Service Information Bulletin

Recall 19V-697 Replacing Oil Cooler

Description	Engineering Designation	Type Code
S 1000 RR	K67	0E23

Identification of components

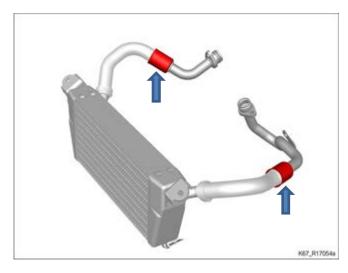
The oil cooler inlet and outlet hoses may develop cracks where the oil hose connects with the oil pipe. If cracks occur, a small amount of oil may leak.

Connection point (Arrows) of oil hose / oil pipe.

- New double crimp (left)
- X Old single crimp (right)

Replace the oil cooler with an updated part.

Existing parts with an old single crimp must not be used.
